Howard County Health Dept. Sanitation Sewage Disposal Testing

APPLICATION

MARYLAND STATE DEPARTMENT OF HEALTH

HOWARD COUNTY 7506 Gallon Tank

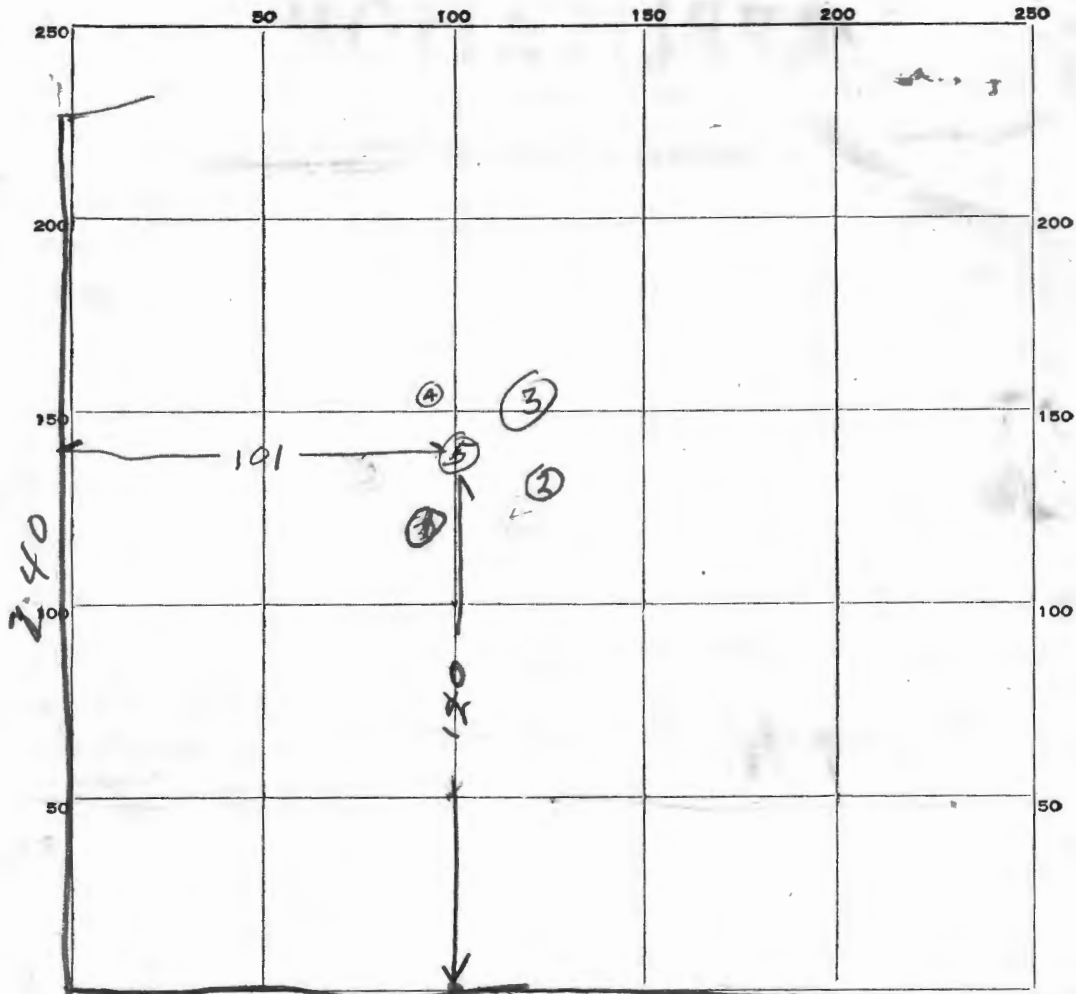
Please place the dry well about 110 ft to 130 ft from the edge of Shady Lane and about 90 ft to 110 ft from the left side of the lot. That is the left side of the lot as seen when facing the lot.

REASONS FOR REJECTION OR HOLDING *8-8-62 dry well rejected due to lack of water in building*

14 AUG 62 No holes dug Back Hoe did not show up RT

*Top 4 ft clay
bottom of well*

Dry Well - 300 sq ft sidewalk area below the top 4 ft of clay

APPROVED BY *Raymond Hodges* FOR Dry Well
